Re: Notice #94445, WS No.LSG-0093, Floodway fringe fill

DAVIS-MOORE NISSAN
SITE PLAN
 WEST KELLOGG

STAFF REPORT

CASE NUMBER: S/D 94-87 DAVIS MOORE 12th ADDITION

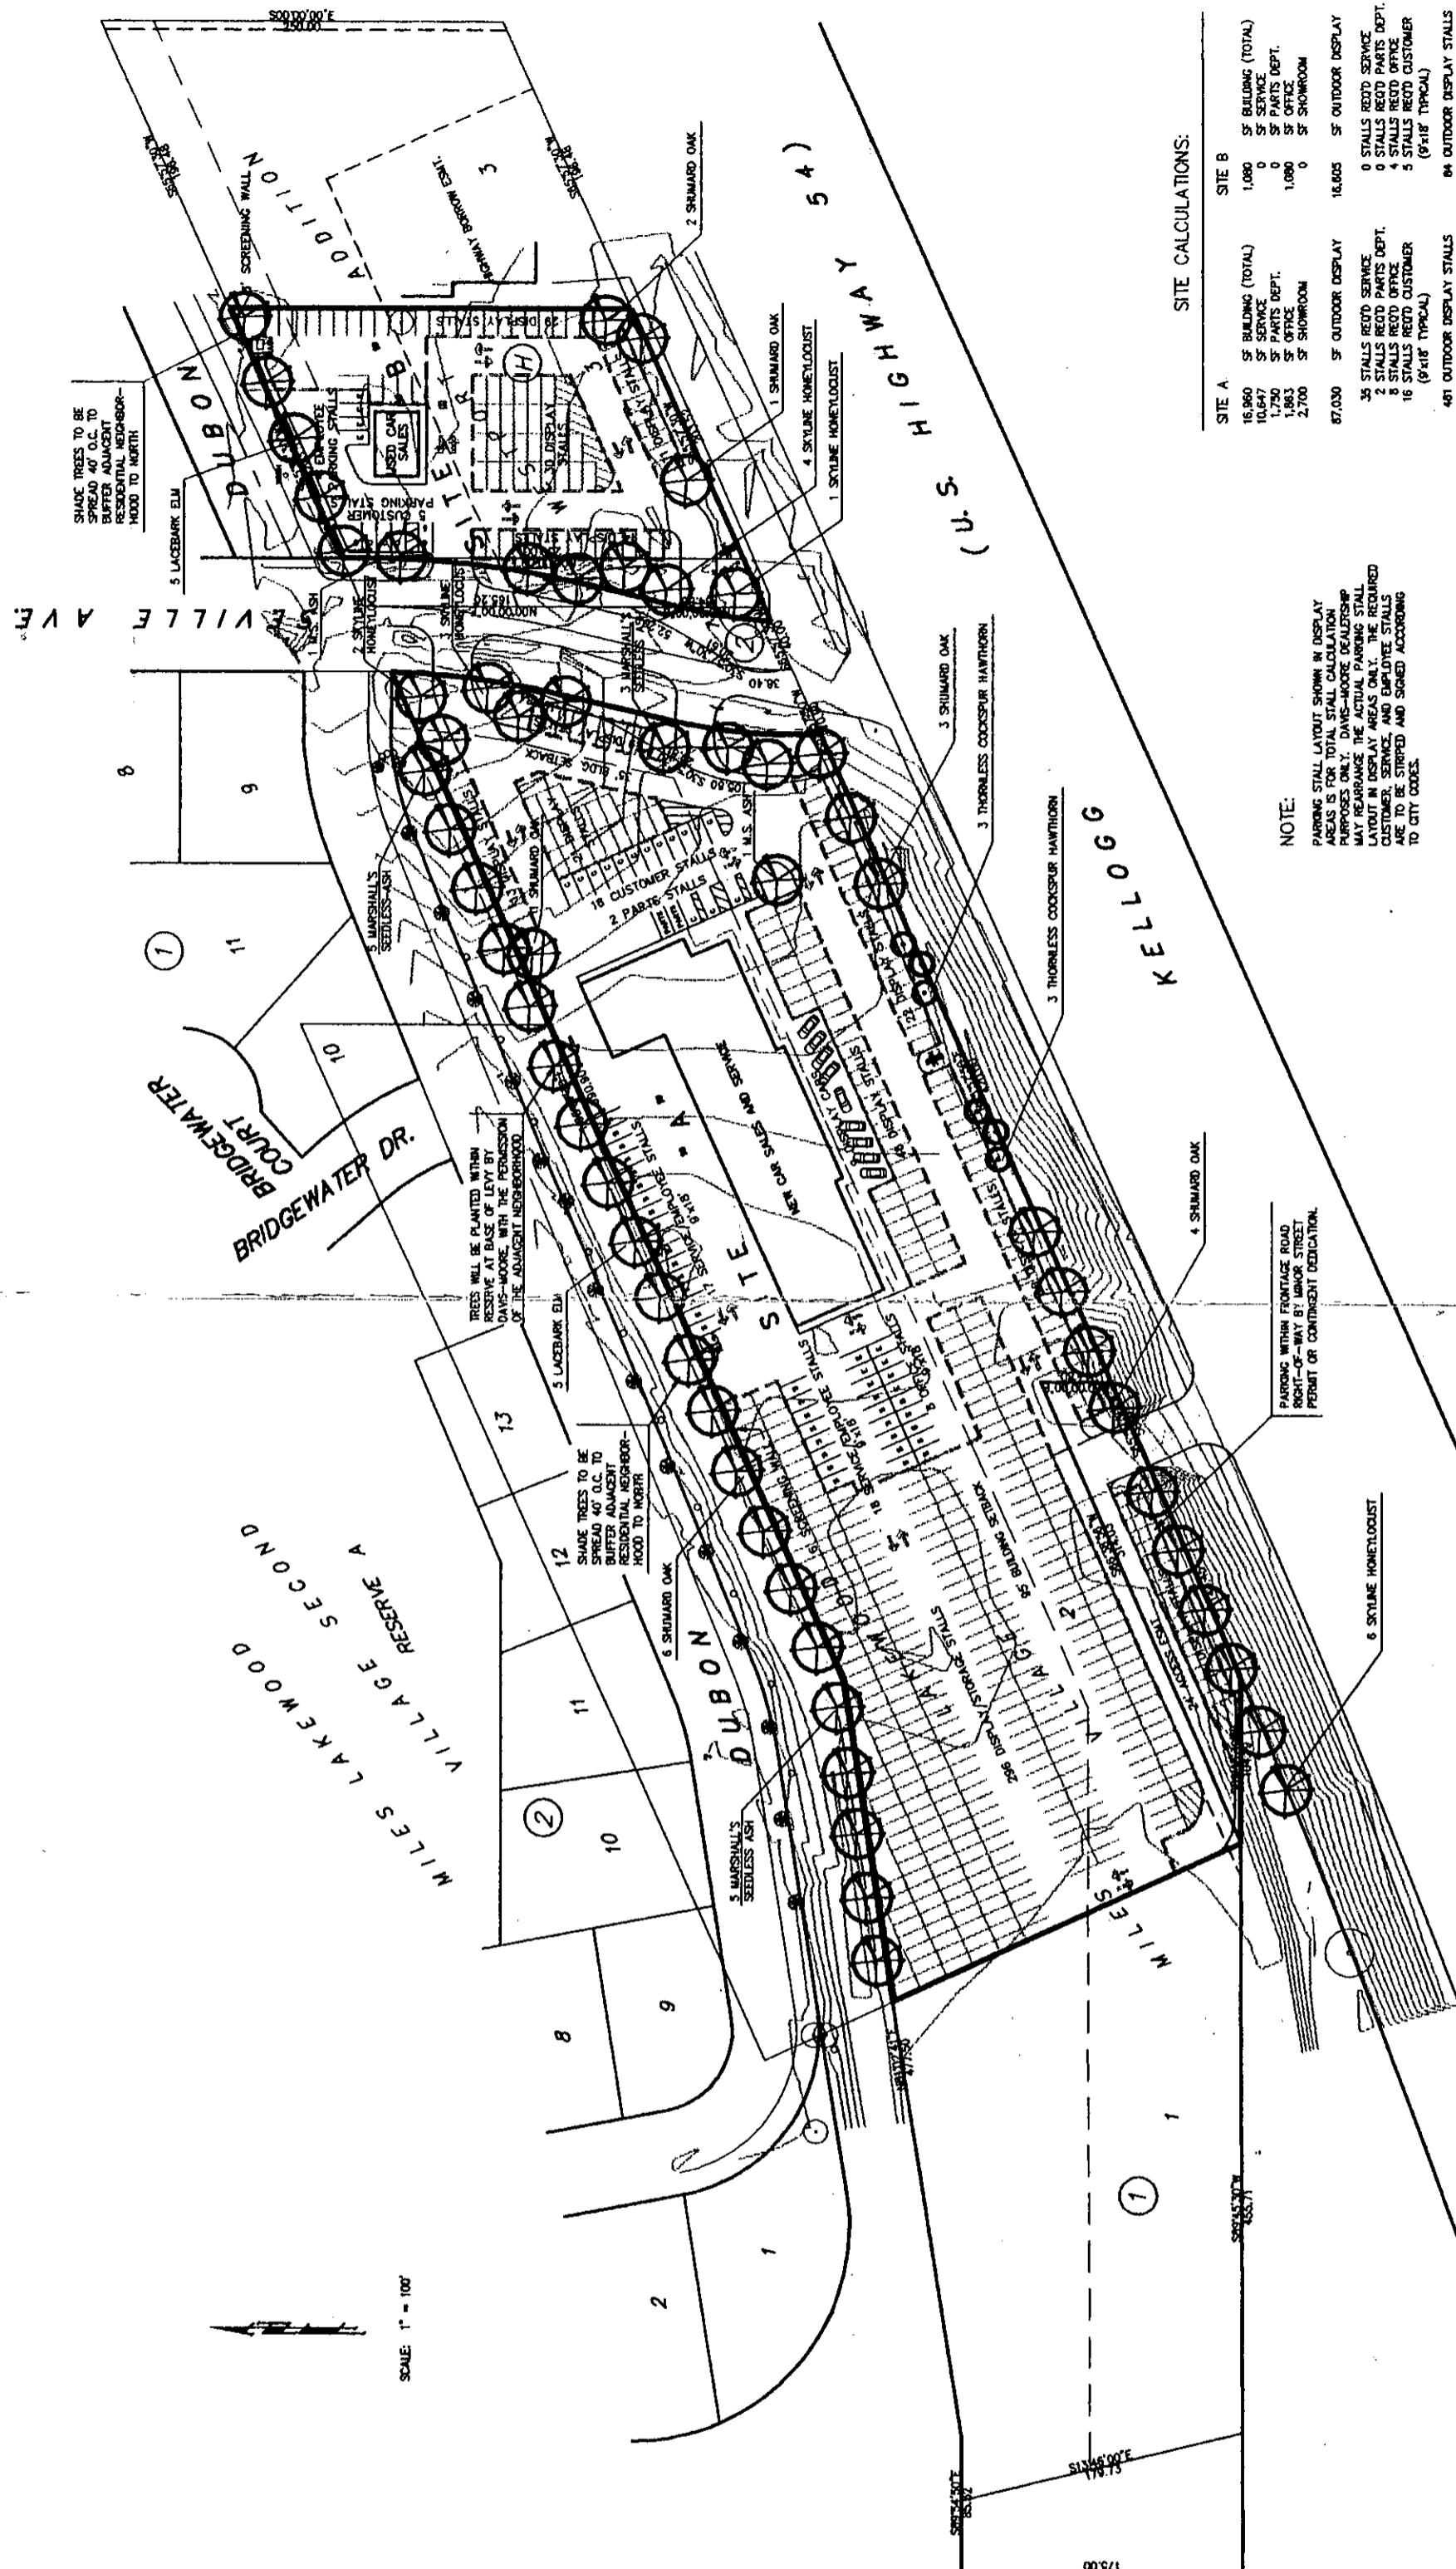
- A. Prior to this plat being scheduled for City Council review, it is recommended that the Subdivision Committee require that the entirety of the site (all of Lot 1, Block 1) be zoned the same ("LC"). Unless under the same zoning, issues of allowed uses, screening, etc. become uncertain if not indeterminable. For example, under "LC" zoning, multiple structures are allowed; however, what happens in the case of a building being allowed in the "AA" portion? That is, can a building be allowed in the "AA" area, if something is already built in the "LC" section or if a residence is in the "AA" area, can anything further be shown or allowed in the "LC" area? Further, for example, certain requirements exist in regard to screening "LC" uses from residential uses. But, does that apply or how would it apply to the same property (lot), under the same ownership?

- B. This site appears to be served by existing municipal water and sanitary sewer. City Engineering needs to indicate if any additional guarantees are needed for these improvements, including any relocations or reconstructions of existing facilities.

- C. Traffic Engineering needs to indicate any traffic improvements needing to be guaranteed to serve this site. Specifically, are any improvements needed at the intersection of Seville and Kellogg or along Seville to serve this site's access at that location. Also, are any improvements needed for the apparent one (1) point of access to Lot 1, Block 1 from/to Kellogg.

- F. City Engineering needs to indicate the acceptability of right-of-way needs at this site, both for Kellogg (including Kellogg Drive indicated as being vacated adjacent to a portion of Lot 1, Block

- G. In regard to access controls, the applicant shall provide proof that the opening to Kellogg from Lot 1, Block 1 is acceptable to the State (is allowed under present access agreements or will be allowed).

For Lot 1, Block 2, complete access control shall be dedicated to Dubon. This is an unpaved street with residential uses along the street's north side and should therefore not be used for access to "LC" uses. For the other lot, an adjacent Reserve in the abutting Addition would appear to prevent access to Dubon.

Traffic Engineering needs to comment upon any other access control requirements such as to Seville, for both lots; e.g., should complete access control be provided immediately north of Kellogg for some distance?

Also, Engineering needs to comment upon floodway, drainage easement, etc. requirements for this site. A floodway was shown on the previous plat of this site, at the western end of this site's Lot 1, Block 1. If a floodway is to be platted, the plat's text shall reference the standard floodway language. Further a major drainage type ditch runs across most of Lot 1, Block 1's frontage to Kellogg.
